Proposal #08: 2722-04-71, WISC 2026434
C New Berlin, Moorland Road
CTH D to STH 59
CTH O
Waukesha County

This is Addendum No. 01, which provides for the following:

ADDENDUM NO. 01

2722-04-71

Addendum No. 01
ID 2722-04-71
Revised Sheet 43
September 3, 2026

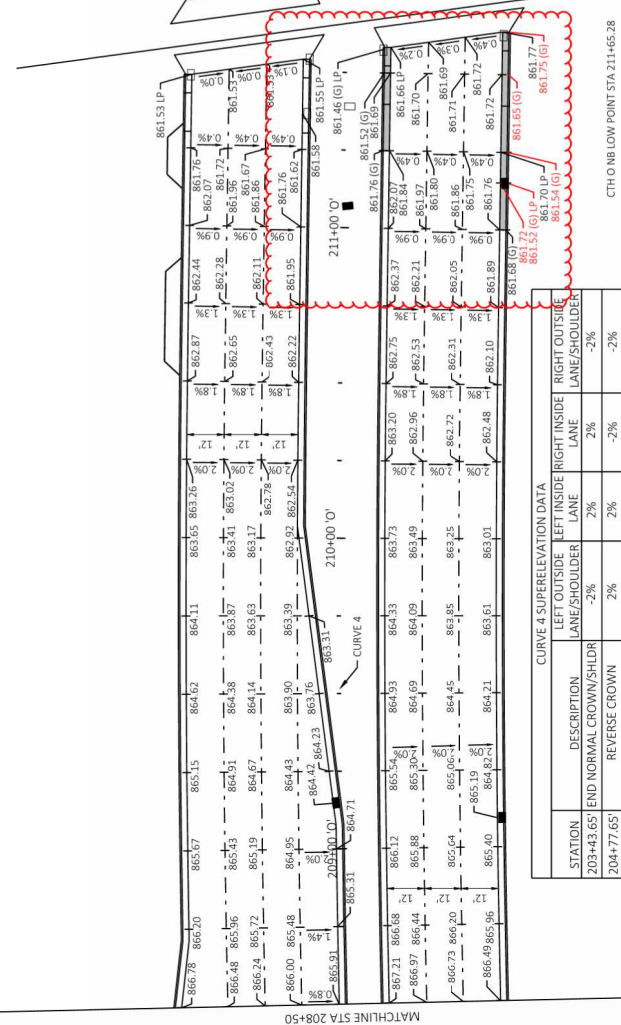
Revised Plan Sheets	
Plan Sheet	Plan Sheet Title (brief description of changes to sheet)
43	Updated sheet to reflect storm sewer pipe and inlets within the UPRR right of way to remain
85	Updated grades on outside curb line of NB roadway
108	Updated Inlet Protection at storm sewer structures in/near the UPRR right of way
139	Updated storm sewer in the UPRR right of way for existing pipe and structures to remain
140	Updated storm sewer in the UPRR right of way for existing pipe and structures to remain
295	Revised call offs for temporary path to Temporary Pedestrian Surface Asphalt
421	Updated quantity of Removing Inlets
422	Removed quantity of Removing Storm Sewer 18-Inch from STA 211+38 to 211+40
424	Updated quantity of Removing Storm Sewer 18-Inch
433	Updated quantity of Cleaning Culvert Pipe, added Cleaning Storm Sewer Pipe, added Cleaning Storm Sewer Structure
442	Updated table for changes to storm sewer near and within the UPRR
